Change to the Structure of Terminal Blocks for CC-Link Communication and External Power Supply Connections

This technical bulletin informs you that the structure of terminal blocks will be changed to meet the UL requirements.

FA-A-0481-A

As an example, the changes to the 7-pin terminal block are shown below.

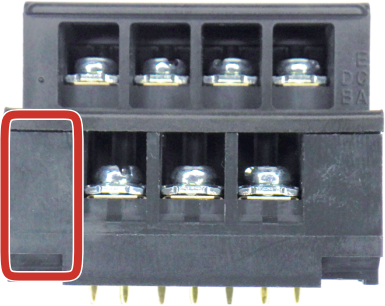
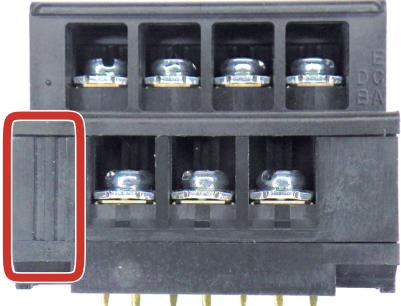
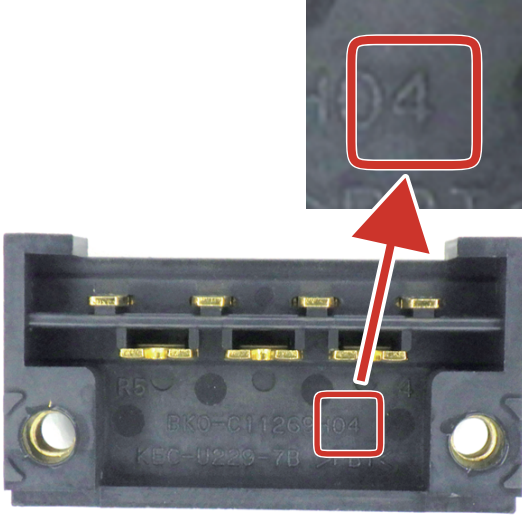
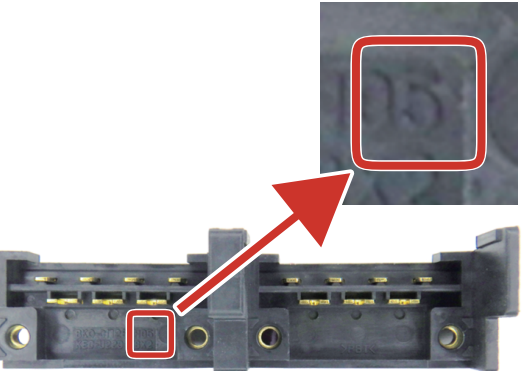
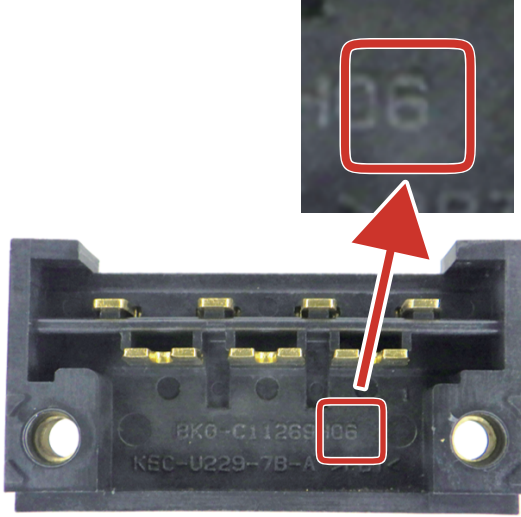
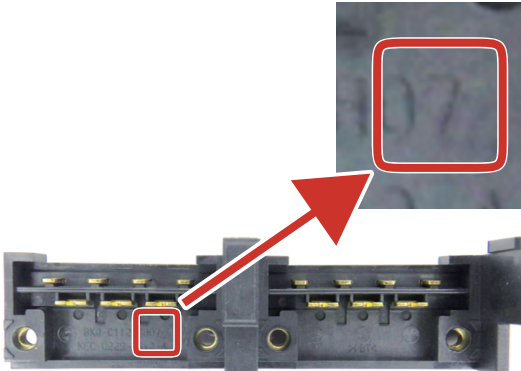
The shape of the terminal blocks and bases (circuit board mounting part), which are used for CC-Link communication and external power supply connections, will be changed.

We added a specification for connecting bare wires (CA: 4) to meet the UL requirements, and we have obtained recertification for the product.

| Product | Part | Before change | After change |
| Terminal block | External appearance |  |  Addition of vertical grooves |
| | Bottom surface |  |  Shape change of some ribs |
| Base (circuit board mounting part) | Top surface |  9K0-C1128SH04 REC-U229-7B->PBT |  9K0-C1128SH06 REC-U229-7B-A->PBT Shape change of some ribs |
